AGL DALTON POWER PROJECT PREFERRED PROJECT REPORT

VISUAL IMPACT ASSESSMENT

FIGURE 4-11

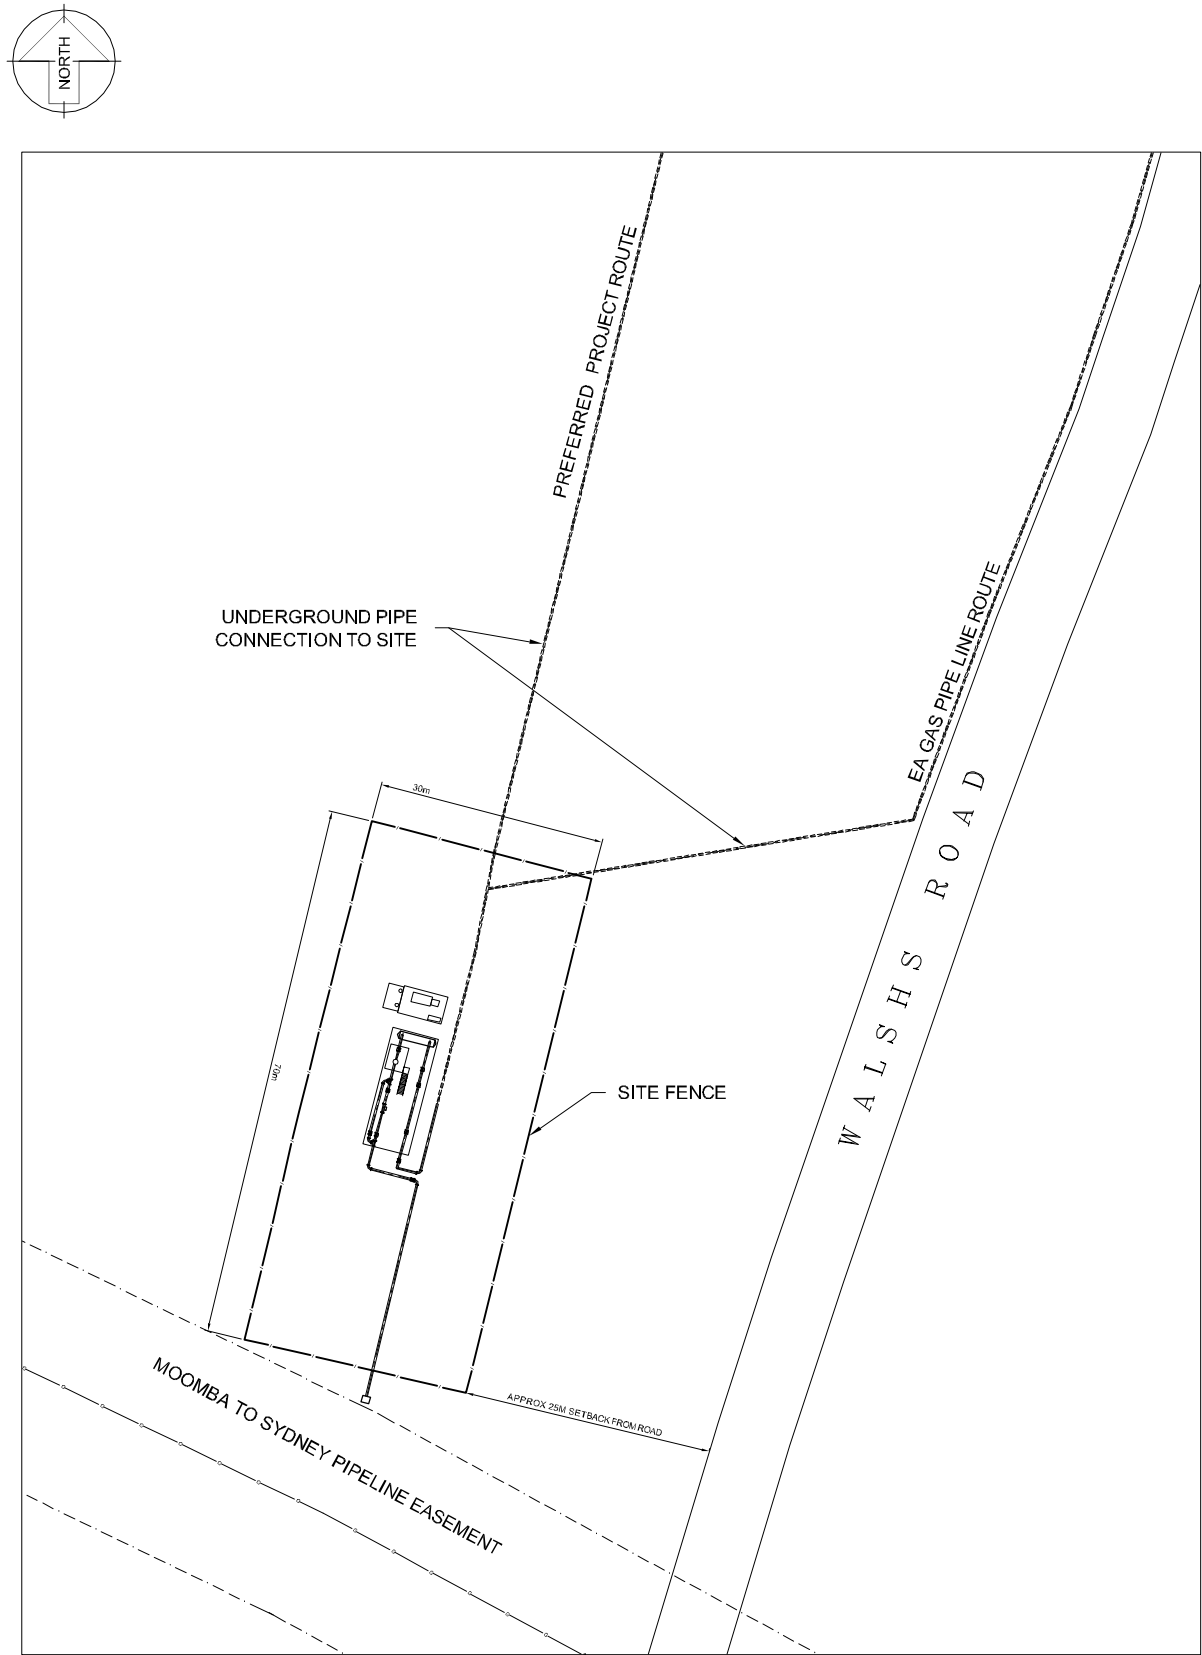
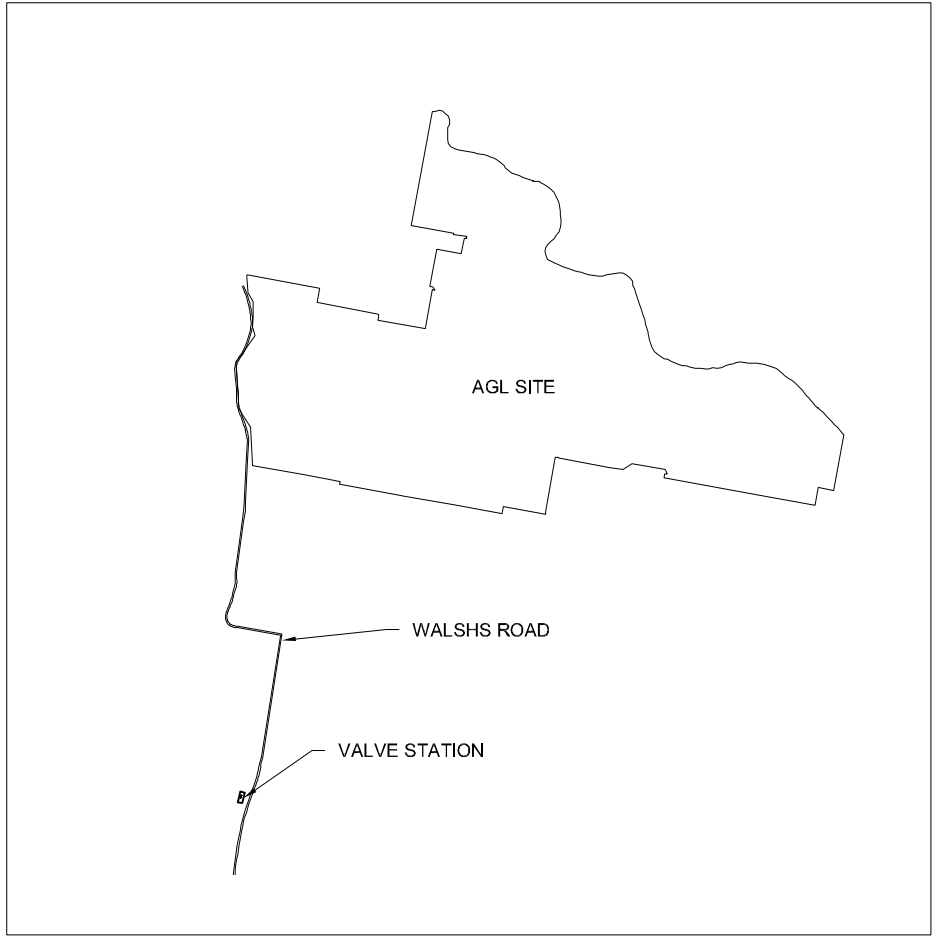
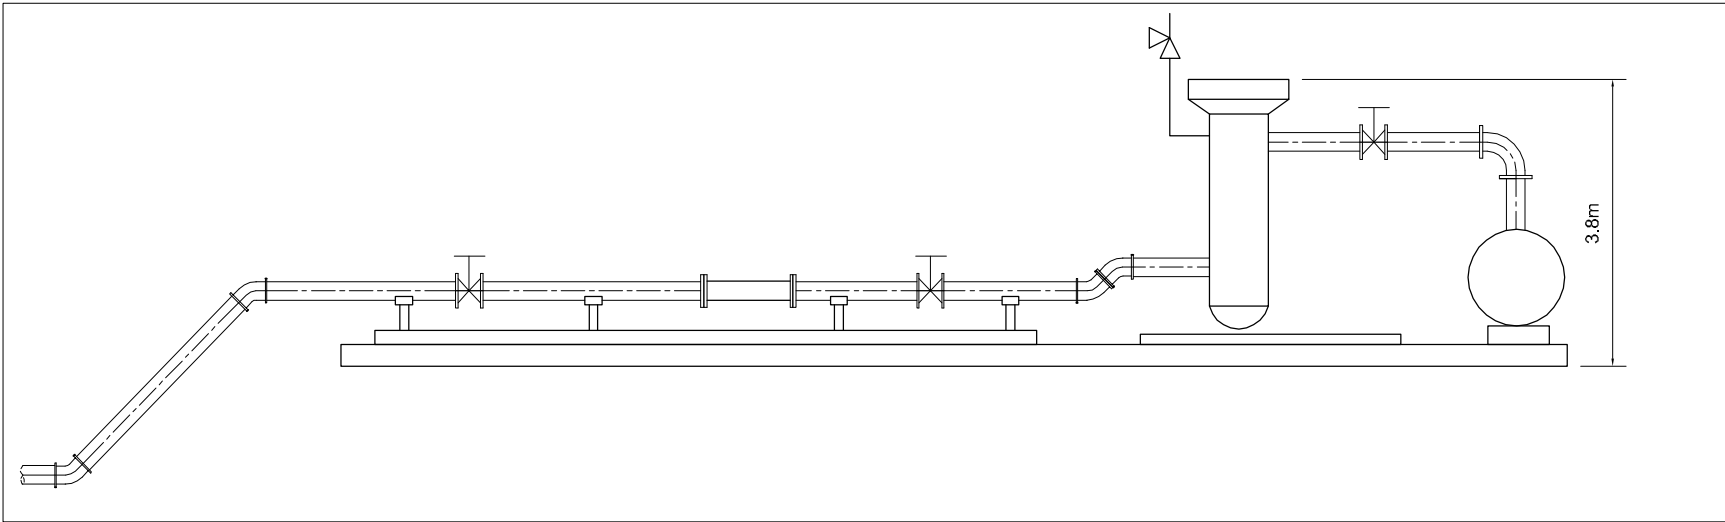
DP&I requested that AGL supply additional plans illustrating the valve station and communications tower:

“ the inclusion of dimensions of the project layout and components, levels and setbacks to the site boundaries within the site concept plan (including scaled, dimensioned plans of the valve station and communications tower)..”

- *The inclusion of dimensions of the power station layout and components, levels and setbacks to the site boundaries within the site concept plan (i.e Figure 4.3 of the EA) represented on A3 sized pages has not been provided.*
- *Elevations from all four sides of the power plant are required. A height is also to be indicated on the communications tower plan.*

Figures 4-11 and **4-12** respectively addresses the request for the valve station and the communication tower.

Figure: 4-13

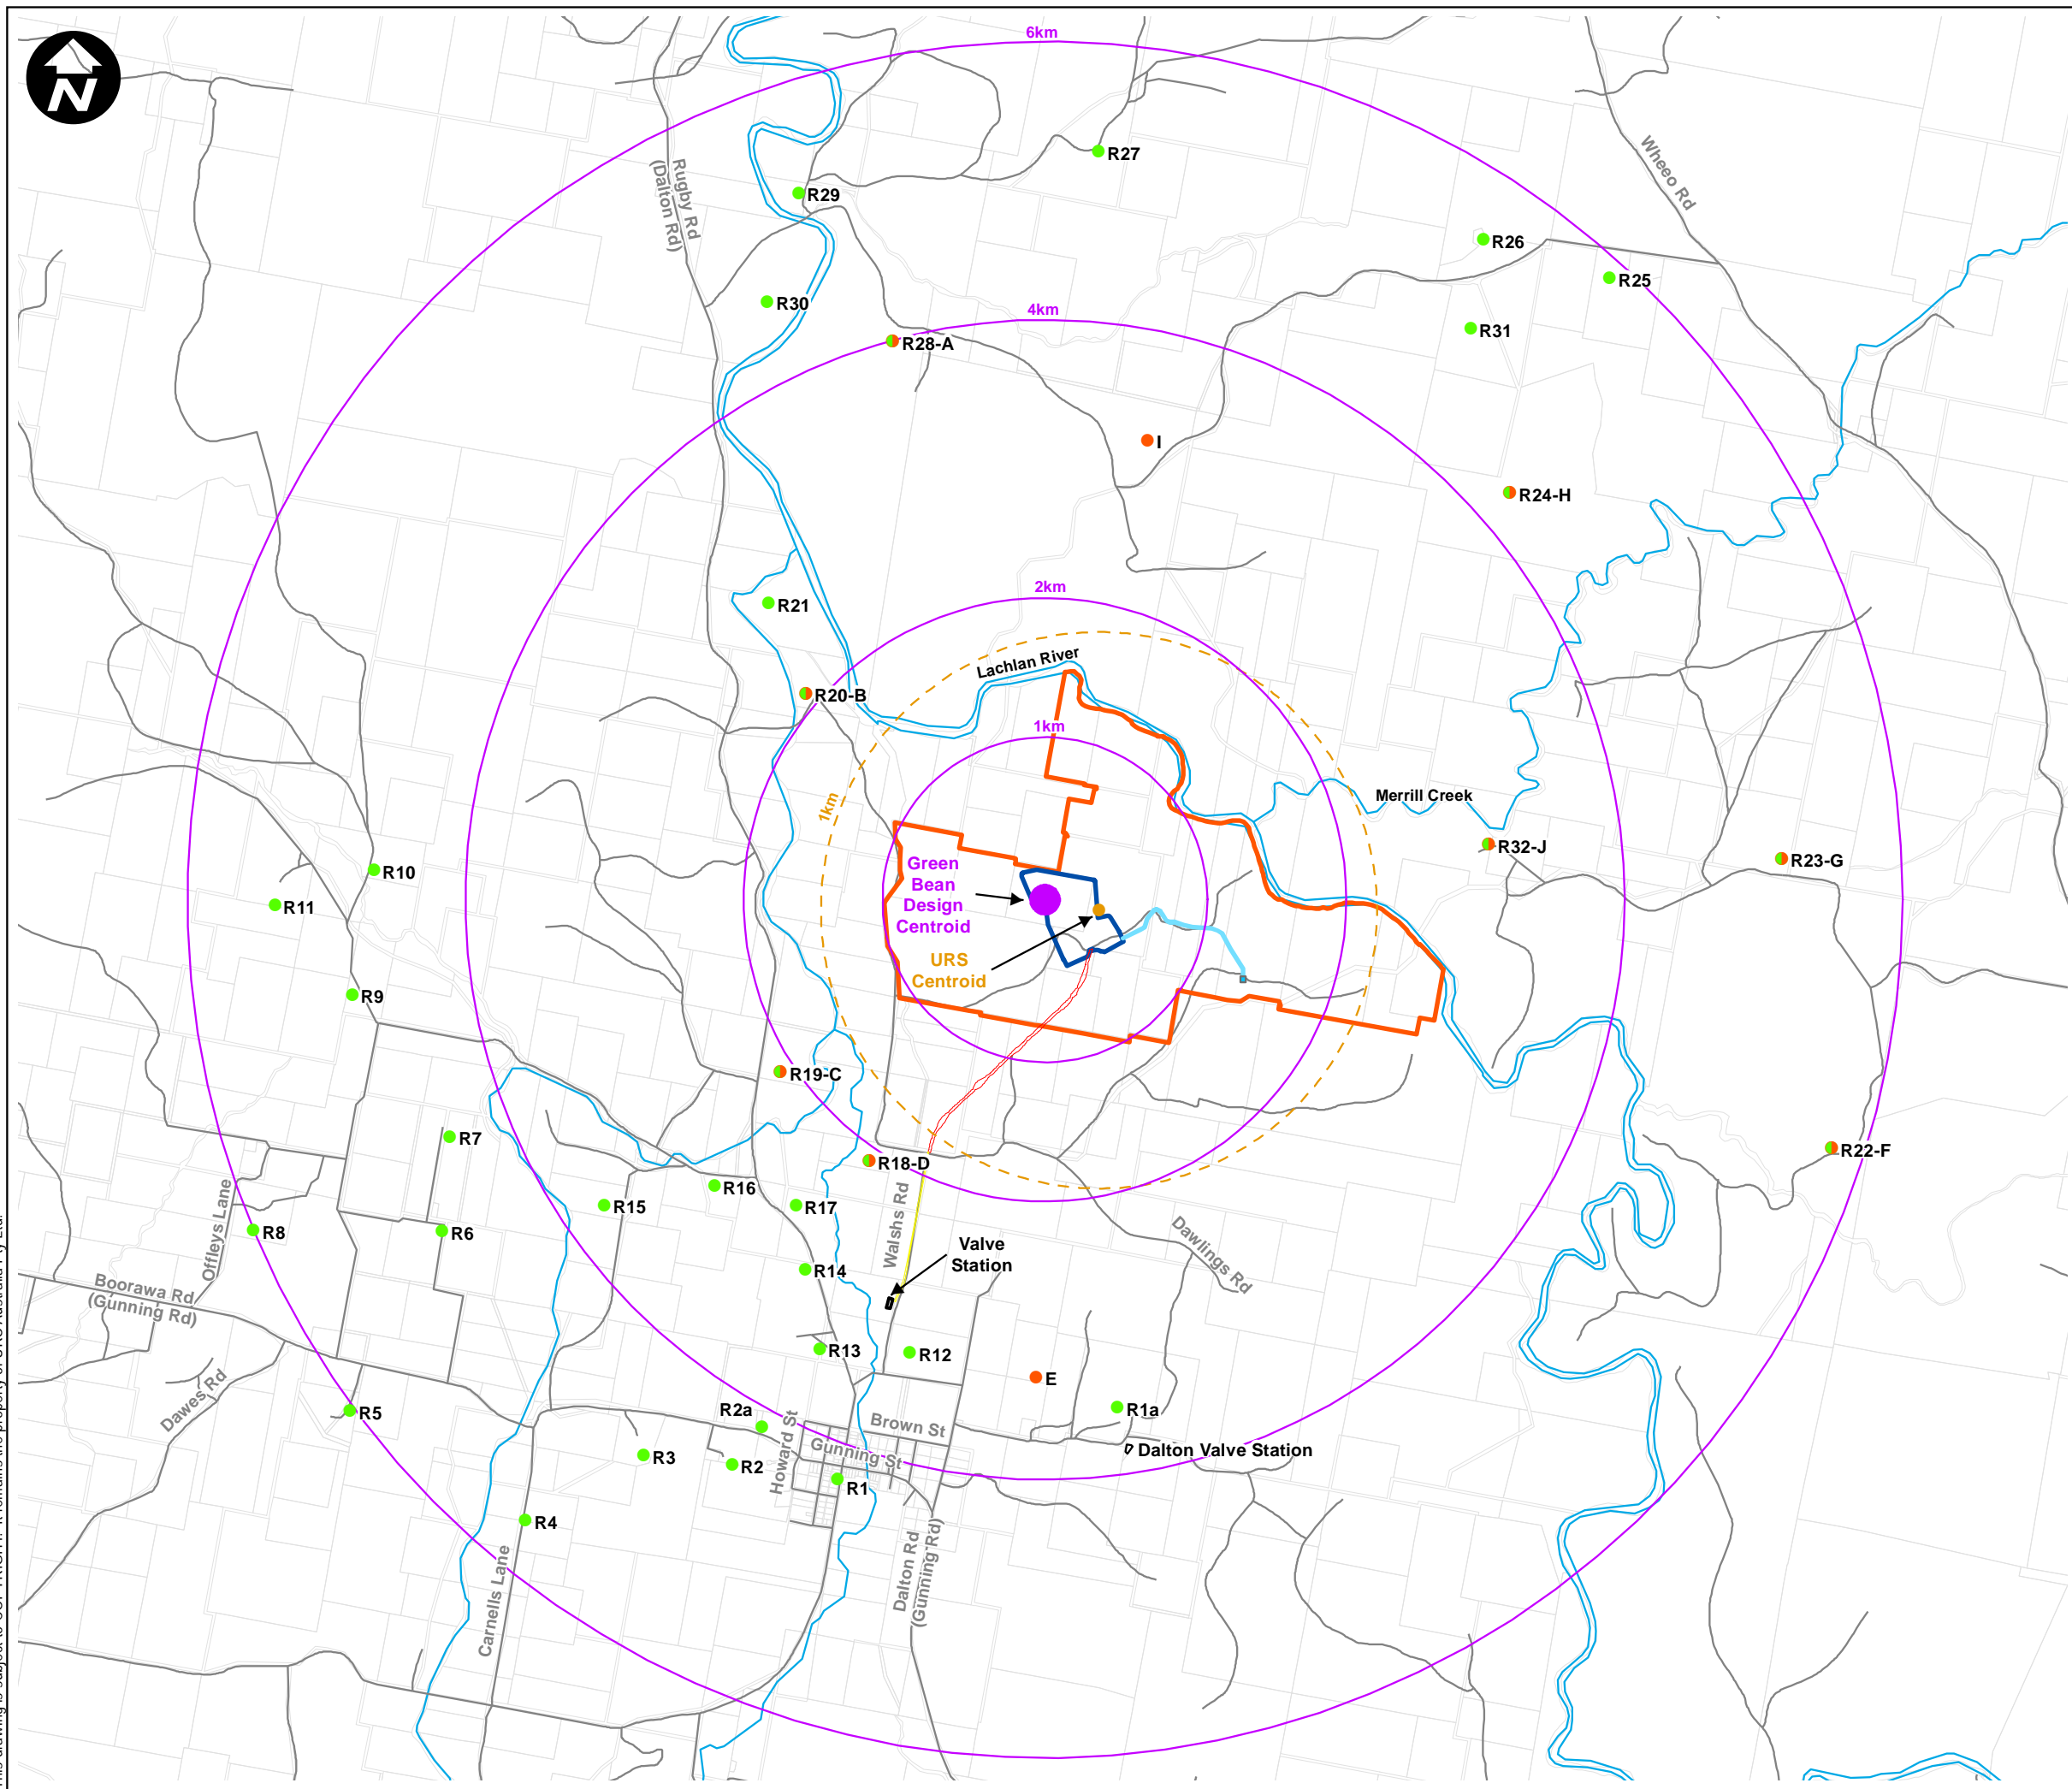
DP&I notes an apparent discrepancy between the residential receptors noted in the noise assessment and the visual and landscape assessment:

"There is a disparity in the identification of the total number of surrounding receptors between the visual and noise assessments. There appears to be additional receptors identified within the visual assessment that have not been considered within the noise assessment, which are located closer to the power station than receptor F. Distances of some receptors to the power station are also different between the two assessments. These discrepancies should be rectified and/or assessments updated".

URS has prepared an additional figure (**Figure 4-13**) to clarify the residential receptor locations discussed and assessed within both the Noise and Visual and Landscape Assessments and which formed part of the EA. From **Figure 4-13**, it can be seen that two slightly different centroids were used between the different technical reports: both centre points are inside the plant footprint and the slight differences in receptor distances quoted are the result of different scales for the figures generated by the technical specialists. Because of this, it is not considered that there is any material discrepancy in the data reported for each receptor location.

From **Figure 4-13**, it can be determined that Receptor J in the noise report corresponds to R32 in the visual assessment, and Receptor G in the noise report corresponds to R23 in the visual assessment.

To the north, the noise assessment identified and assessed potential impacts from Receptor I which was not included in the visual and landscape assessment. At the time of the Noise Assessment, this receptor location was included as it was unclear from aerial imagery whether this location was an existing house or a potential building site. To adopt a precautionary approach, it was included in the assessment. Subsequent field visits made by the landscape and visual consultant have confirmed that no residential building exists at this site. For this reason, the visual report did not include this location. This discrepancy is noted. However, there is no material impact on the findings of either the NIA or the VIA.

To the South, Location E as considered by the Noise Assessment refers to the same receptor location as the visual R1a location. The R1a location as plotted within the figure produced for the visual and landscape assessment is placed between two built structures on the property. However, it is confirmed that both the noise and landscape assessment included assessment of the built structure which is the residential building on this property.
